MEMORANDUM

RE: Response to Comments on NOI for DEP #CE 204-0991, The Reconstruction of Foster Street in Littleton, MA

RE: Stormwater Analysis
Reconstruction of Foster Street Project (MassDOT Project #609054)
MassDEP File #204-0991

CROSS SECTIONS

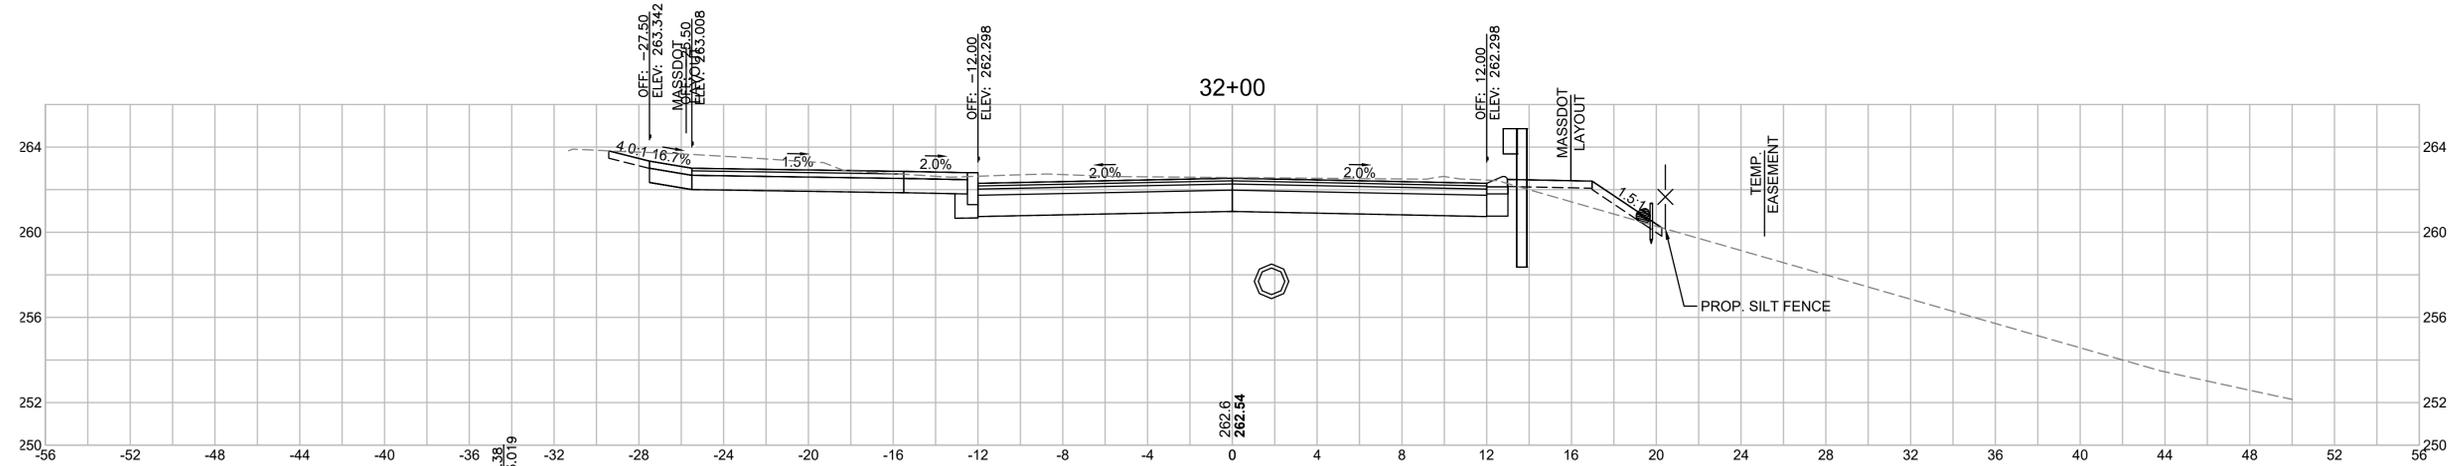
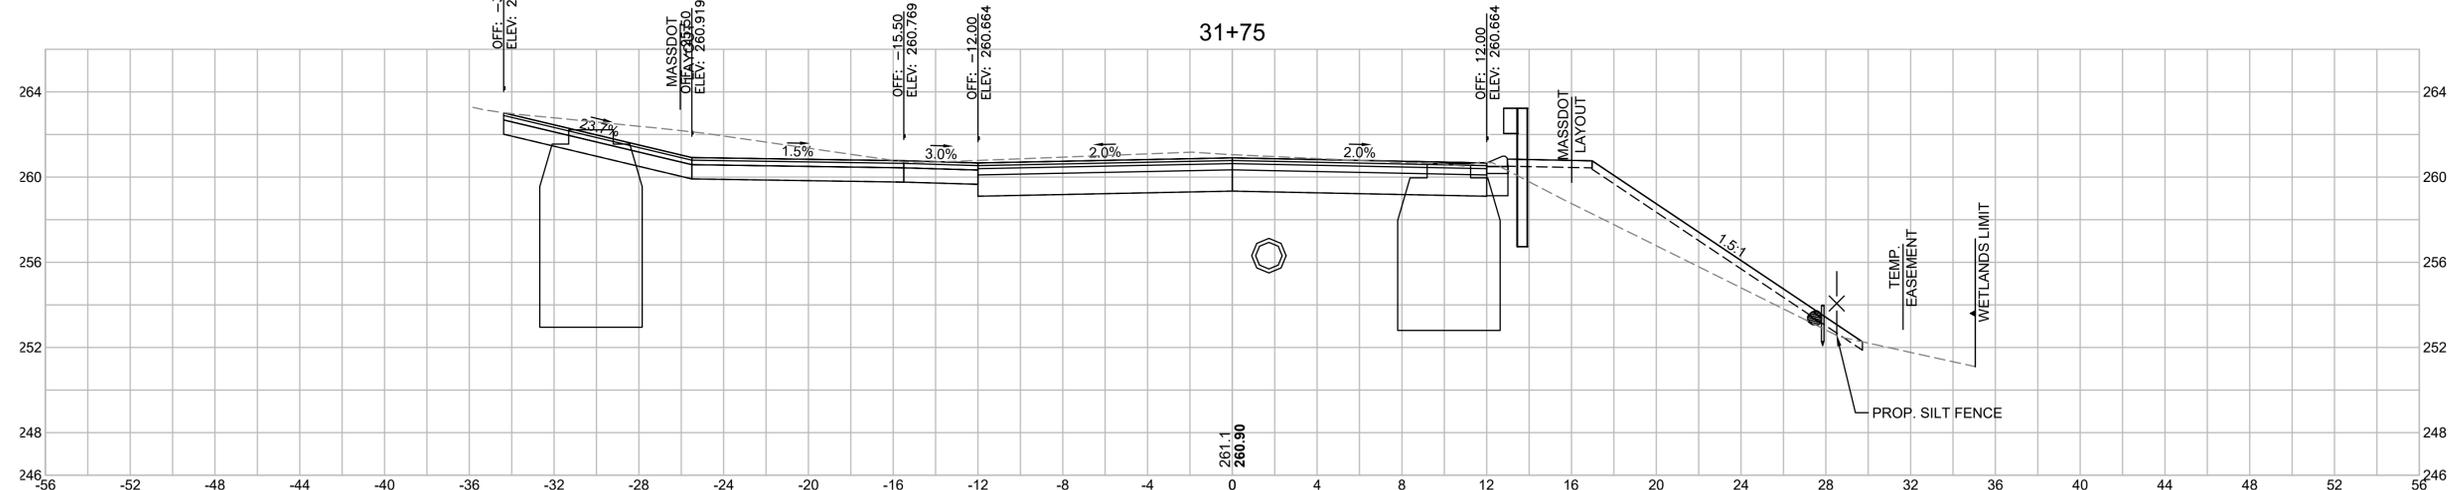
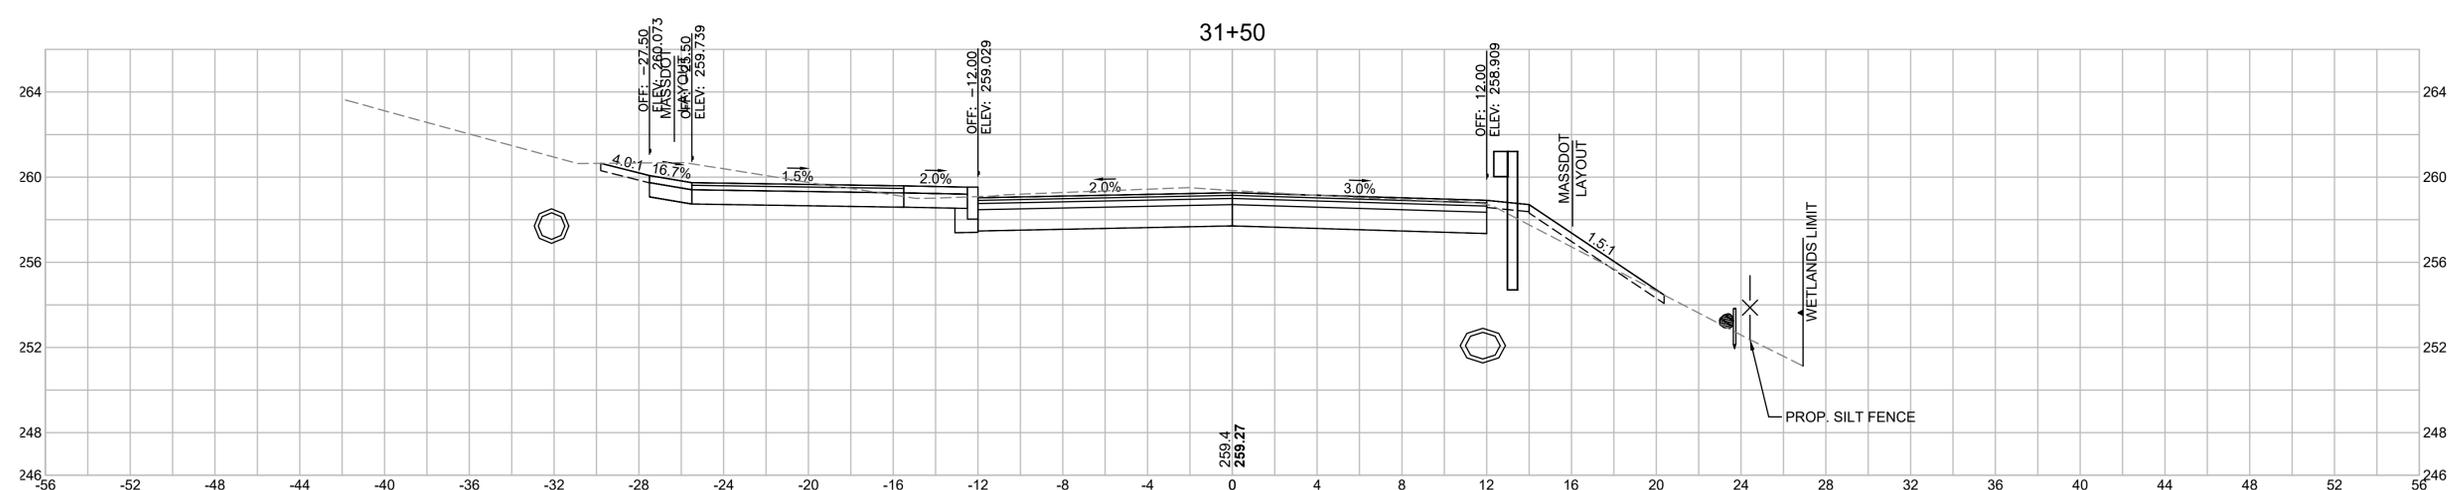
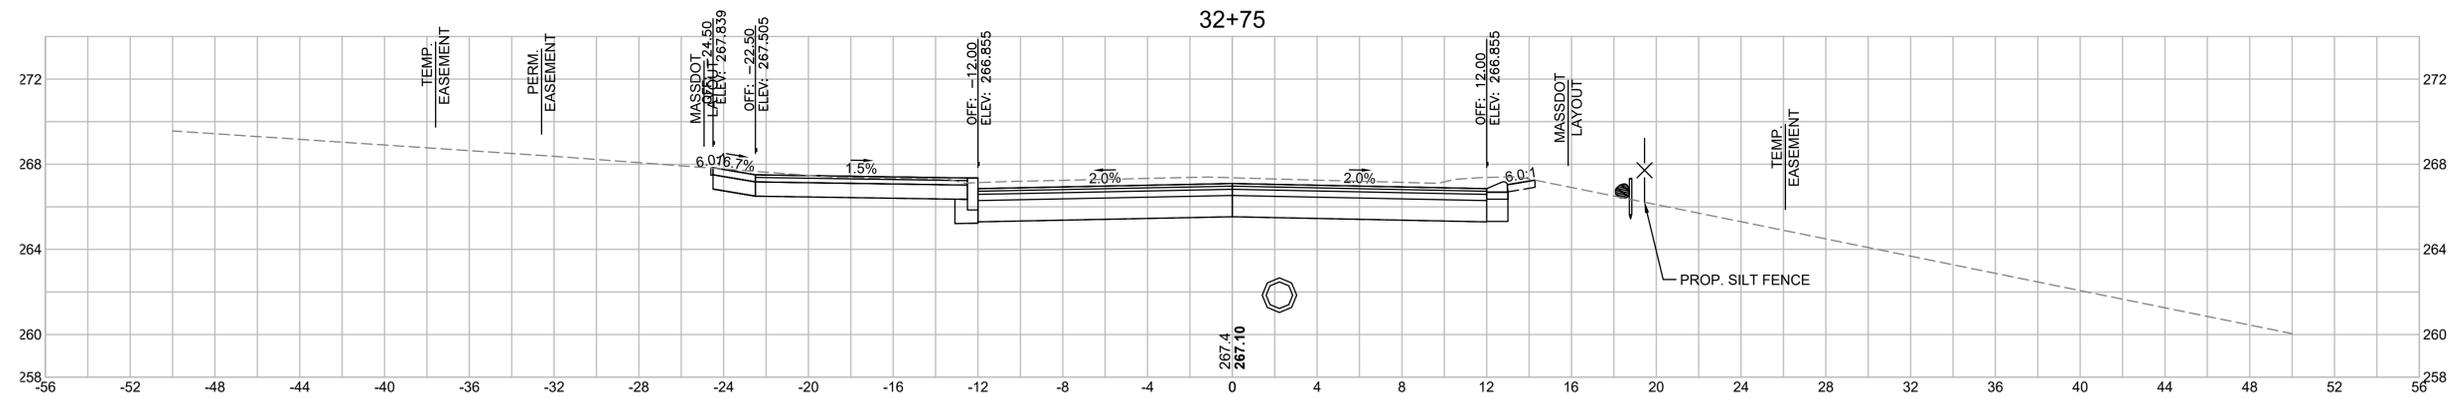
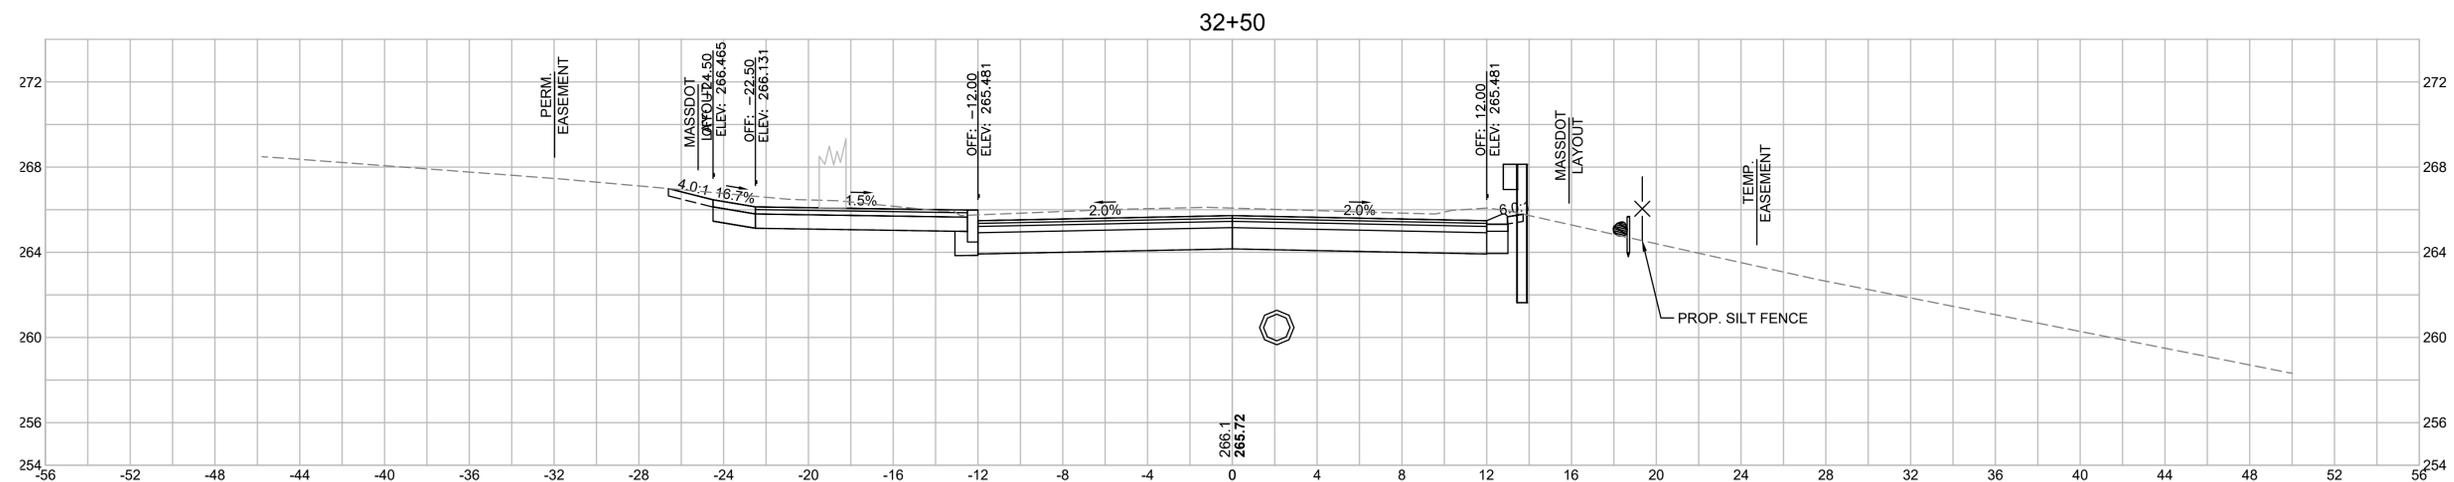
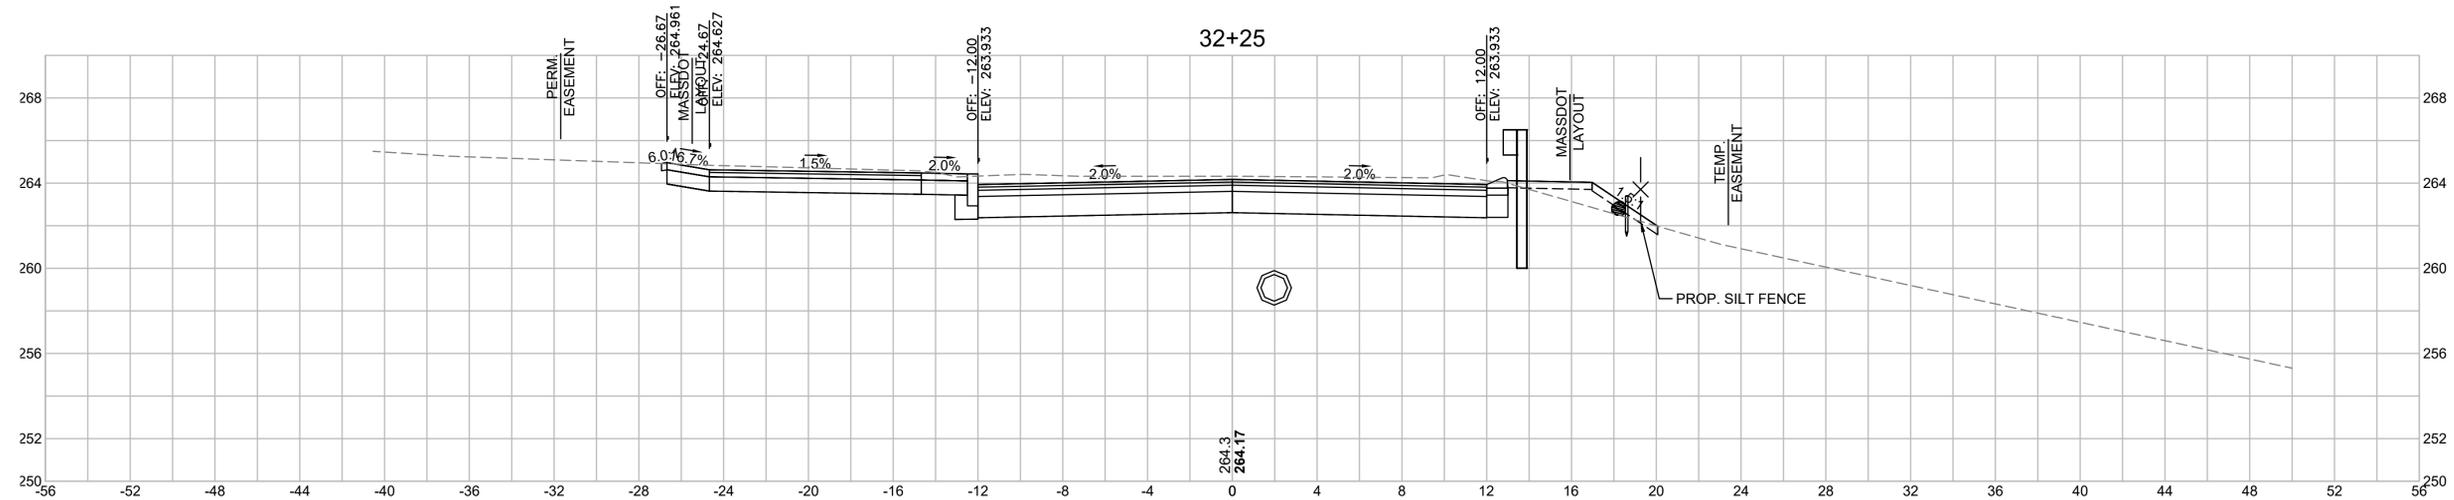
- The edge of road is moving 3 feet toward the 260 Foster St parcel Durkee Farms. This will move the embankment of Foster St closer to the wetland basin. Commissioners raised concerns about diminished stormwater storage in the wetland basin on 260 Foster St. Commissioners raised concerns that the entire slope will need to be shifted to accommodate the top of the slope and proposed slope stability, and shifting the slope to the south will (1) include work beyond the currently identified extent of work; (2) impact buffer zone in ways that are not currently shown on the plans and may fill resource areas; (3) to the extent shifting the slope adds backfill around the base of trees, those trees will ultimately die. F&O was advised that the extents of work do not appear to be realistic given the slopes and grades. This condition was subsequently discussed at many other areas. F&O was advised by Commissioners that work outside of the plan-defined limits of work will not be allowed.

- Commissioners requested to see the cross sections at locations where Foster St is proposed to be moved.

F&O Response #4: Cross sections are provided in Attachment 3 for where the Foster Street alignment will shift toward the frontage of 260 Foster Street. The cross sections show: 1) the fill areas proposed to stabilize the proposed shoulder embankment, 2) the placement of the proposed erosion controls, 3) the proposed limit of work, and 4) the wetland boundary.

The proposed embankment will be constructed using gravel borrow and crushed stone meeting MassDOT's material standards and then compacted for stability to MassDOT specification. Where embankment slopes are 2:1 or steeper, the project calls for the use of modified rockfill to supplement slope stability and prevent slope erosion. The specification for modified rockfill is included in Attachment 4, a detail of modified rockfill is included in Attachment 3. Callouts have been added to the construction plans showing the areas where the use of modified rockfill shall be used at the frontage of 260 Foster Street, between Stations 30+33 to 32+09.

GRIMES LANE - CROSS SECTIONS

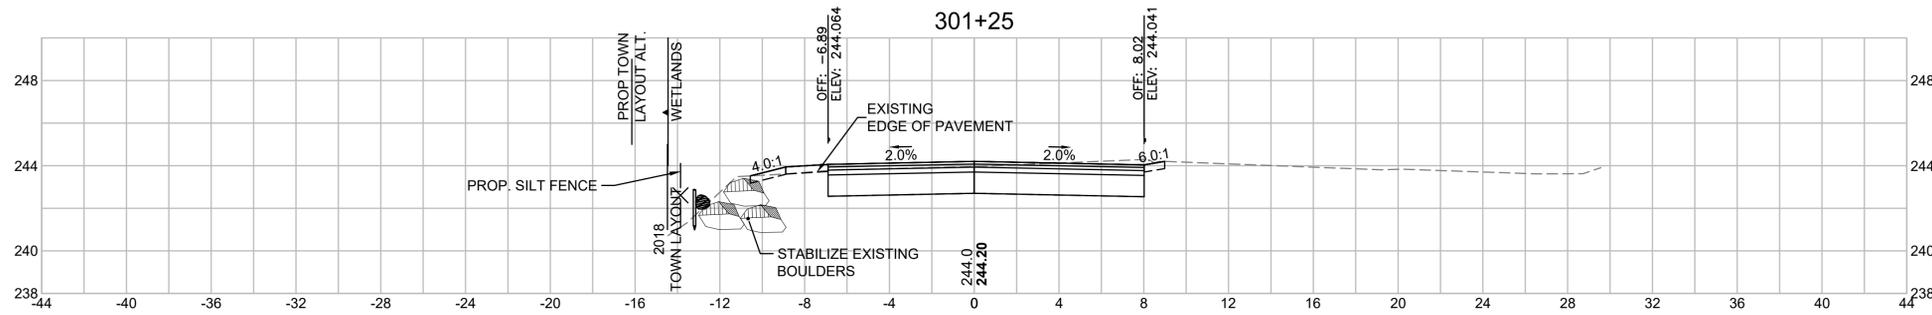
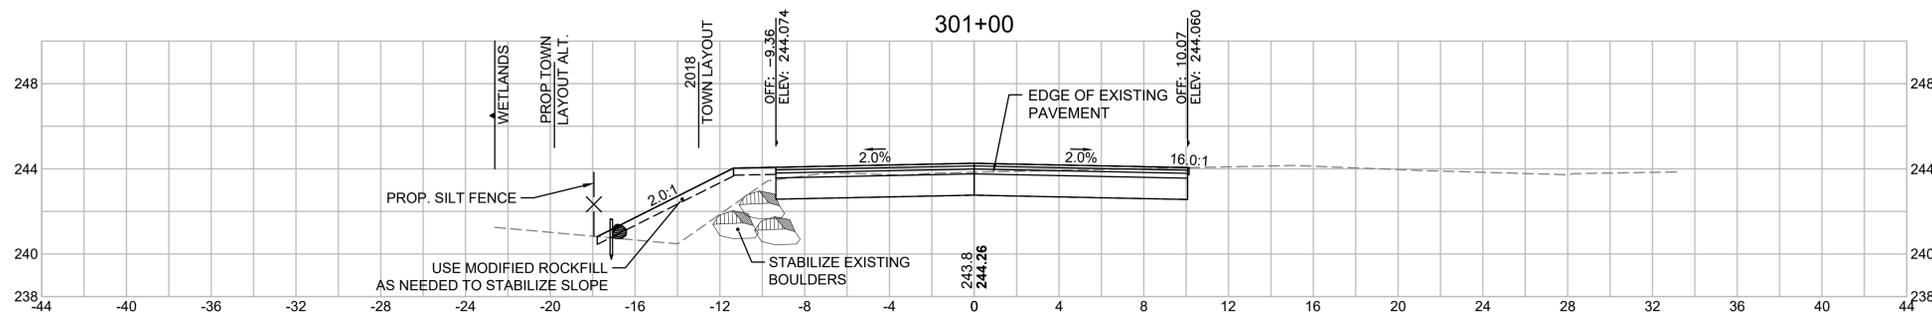
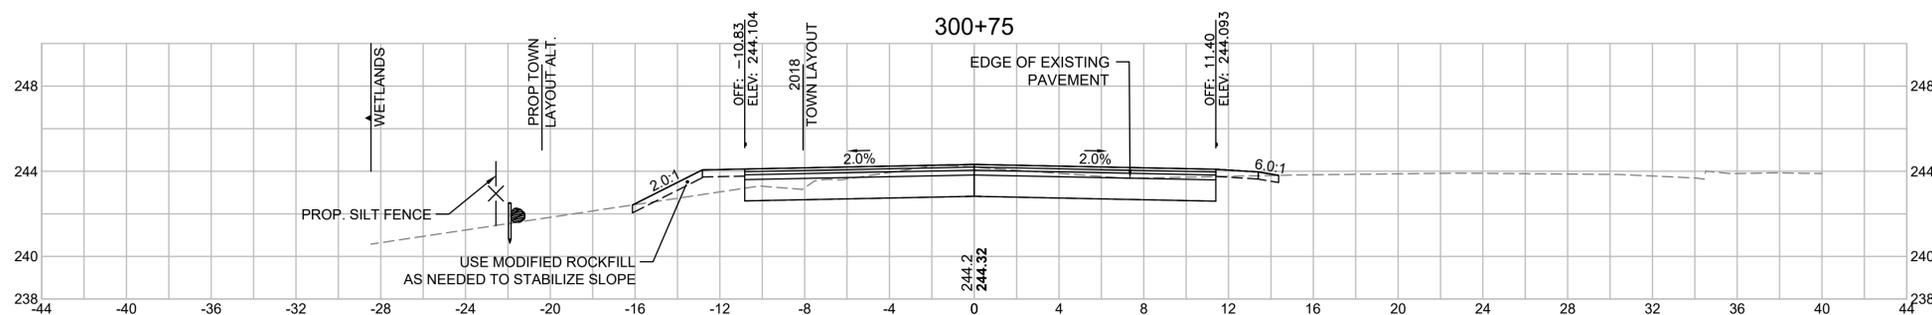
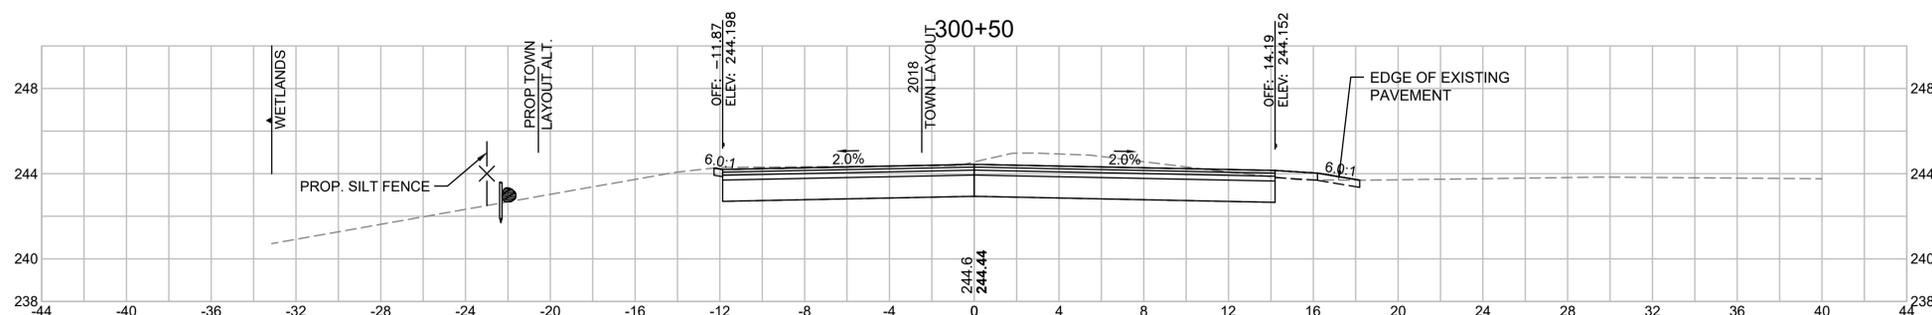
- Commissioners asked about how the embankment on the east side of Grimes Lane would be kept stable during construction.

- Commissioners questioned how the limit of grading would be kept away from the adjacent wetland on the east side of Grimes Lane.

F&O Response #5: Cross sections are provided in Attachment 3 for the Grimes Lane alignment that will shift toward the parcel at 260 Foster containing an adjacent wetland.

After the Commissioner's site walk held on 11/02/2023, F&O designers adjusted the proposed edge of road at Grimes Lane starting from the beginning of work, Station 301+41, to match the existing edge of road for 15 additional feet. This was done to pull back the limit of work 1 foot away compared to previous at the shoulder of Grimes Lane to the maximum extent possible. Attachment 3 shows an updated construction plan sheet at Grimes Lane.

14 BALANCE STONE WALL REMOVED AND REBUILT, DRY
SCALE: N.T.S.

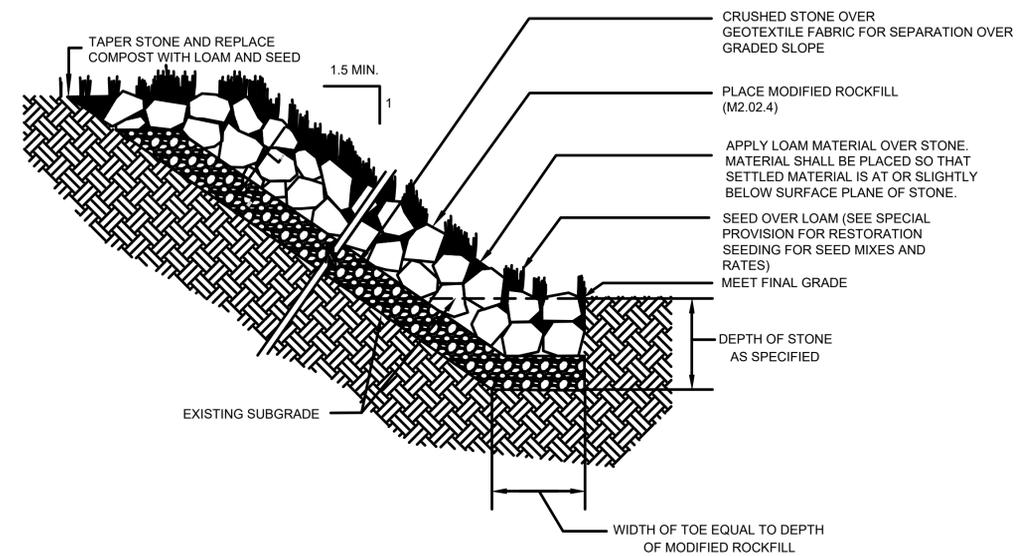
- Commissioners noted that the limit of work on Grimes Lane is immediately adjacent to, and in some locations directly on top of, a historic stone wall. F&O stated that no structural stability evaluations have been done on the stone wall. An unidentified member of the public who briefly joined the site walk noted that periodically sink holes form on or adjacent to the road surface as soil erodes through cracks in the wall and washes soil on the road surface away. Commissioners noted that some large stones associated with the wall have apparently fallen into the wetland. Commissioners questioned the structural stability of the wall, how F&O plans to manage the wall during construction, and potential wetland impacts if the wall were to fall during construction. F&O was advised to consider construction

impacts on the wall (e.g., vibratory rollers on top of a historic stone wall), the wall's long-term stability, and wetland/buffer zone impacts associated with managing the wall during and after construction.

The contractor will be directed to stabilize the embankment boulders using a work item specification already included in the project to rebuild dry stacked stone walls. Using this work item will ensure that the contractor has a payment item available for workers to stabilize the embankment boulders by manual means if necessary. No boulders that may have already dislodged from the embankment and moved outside of the limit of work will be retrieved. The contractor will be directed to supplement the embankment with new modified rockfill material as needed to achieve a stable embankment meeting MassDOT inspection standard for compaction and stability. The embankment will be fortified to provide integrity during subsequent construction of the subbase and surface of Grimes Lane.
